Basis of Design Report: Draft Final (95%)

Bird Track Springs Habitat
Improvement Project

December 15, 2017

2 30% Design RRT Comment Response

Figure 2-1. Modified floodplain features.

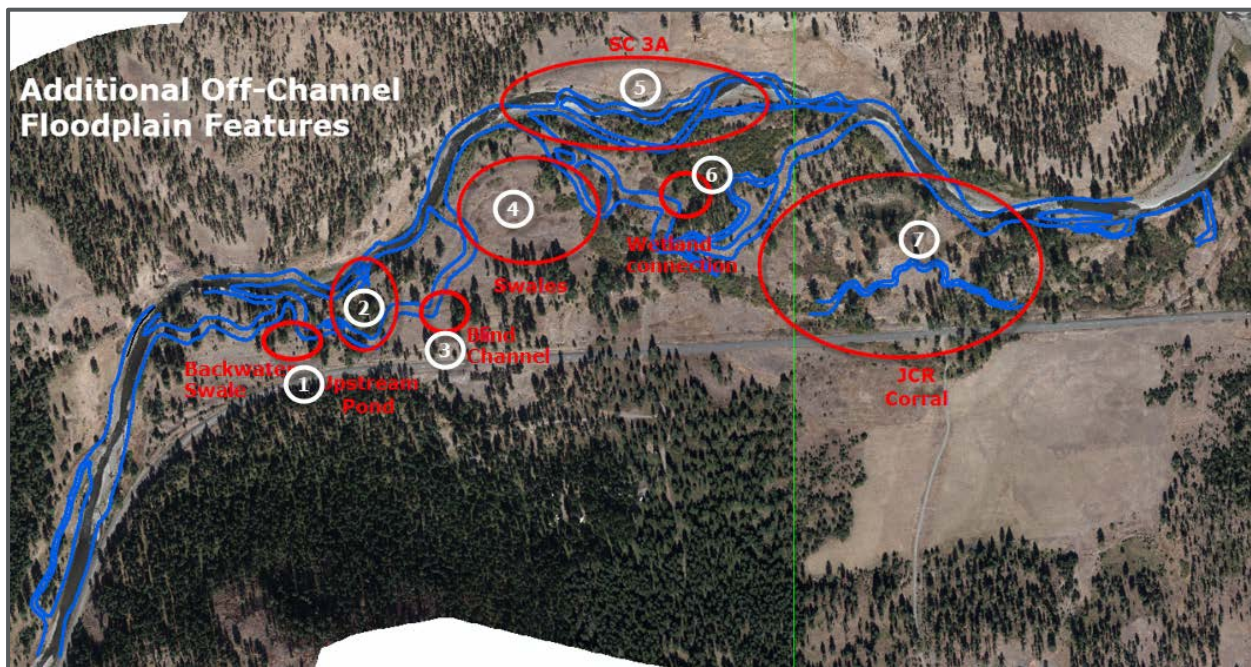
- b. Incorporation and design of more low-velocity off-channel habitats as described in the British Columbia Fish Habitat Rehabilitation Manual, Chapter 7; including rearing ponds, hyporheic off channel habitats, alcoves and other low velocity, bio-energetically favorable habitats to support summer and winter rearing for salmonids. Several examples of fish growth response, improved water quality effects (temperature) and increased valley bottom water storage were discussed.

We had planned to further develop additional floodplain features after the 30% review to include more off-channel habitat elements. As a result of this comment we have added and modified some additional

features. Significant additional floodplain features that were added and/or modified between the 30% and 80% design are shown in Figure 2-1 and described below. Additional detail for each of these features can be found in the design plans.

1. Main Channel (MC) Station 28+00 – Backwater swale – A flood swale was graded in the floodplain as additional flood flows will inundate this area due to removal of the upstream railroad spur along the river near MC stations 12+00 to 15+00. The outlet of this swale near MC 28+00 was graded to exit in a channel backwater alcove feature that will serve two purposes, to provide low velocity habitat and high flow refugia for salmonids and to provide energy dissipation for re-entry of flood flows back to the main channel.

2. MC Station 31+00 – Upstream pond (Beaver Pond 1) – An existing depression from a former channel meander scar will be connected to high flows and through hyporheic inputs between MC Station 31+00 and Side Channel (SC) 2 Station 16+00. Backwater will be provided through placement of a reinforced habitat structure located near the outlet into SC 2. To provide additional depth and cold-water inputs during low flow conditions, the depression will be partially excavated as shown in grading plans.

4. MC Station 42+00 – Swales – An existing channel network consisting of three distinct swales in an open field will be further graded and enhanced. During construction, this area is planned to be used as a large staging and sorting area that will experience significant construction impacts. Once construction is nearly complete, the floodplain and swale network will be re-graded and reconnected. Additional grading in this area includes a wide over-flow from MC station 42+00 that gets routed into individual swale all leading to perennial pond features that are graded and

connected to SC 4. Pond features are backwatered with reinforced habitat structures that are then connected to SC 4 through perennial alcoves. Each pond will provide excellent depth and velocity conditions for juvenile salmonids with cover. Ponds receive surface flows through the graded floodplain at flows at and exceeding the winter high flow (900 cfs). Hyporheic inputs are expected at low water conditions.

6. MC Station 60+00 – Existing wetland connection – A large wetland feature currently exists on the floodplain south of the existing channel and was formerly occupied by a beaver colony. It is currently unknown if beaver still reside within this wetland feature or are transient. The proposed project will provide increased connectivity to this large floodplain feature by virtually surrounding it at higher discharges. Access for juvenile fish to this feature will be much improved as side channels 3 and 5 are located adjacent to its boundaries. To improve surface connectivity, a small channel was graded into an existing swale feature near MC station 60+00. This graded channel will provide upstream surface connection at the winter high flow discharge (900 cfs) and above.

Figure 2-2. Proposed sustainable deep pools.

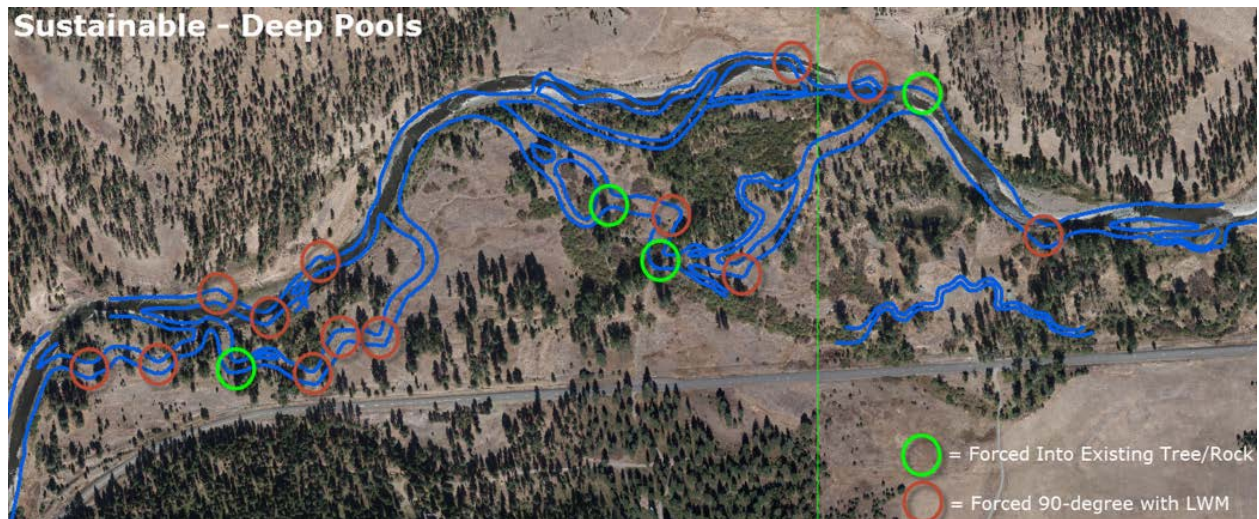
- e. Provided existing examples and suggestion to create more sustainable pools that mimic natural features with upstream high velocity zones that abruptly change channel direction (i.e., 90-degree bends) and re-partition energy into channel bed for sustainability. Suggest this should be added to the “quiver” of options and use both placed wood features and directed at existing large trees.

The project team agrees with ODFW regarding this design philosophy. The design team had planned to further incorporate these grading details for locations where major pools are expected after 30% design. Additional design has included the development of 90 degree bends through channel grading in combination with specific constructed large wood features and existing features (trees and rock) that have been designed to force the bulk of high flow discharges into these structures for pool development and maintenance. Deep pools have been designed using both constructed large wood features and existing trees at multiple locations. Additionally, upstream energy has been purposely maintained to provide maximum pool development. Larger pools that will be created under proposed conditions, using this design philosophy, are identified Figure 2-2.
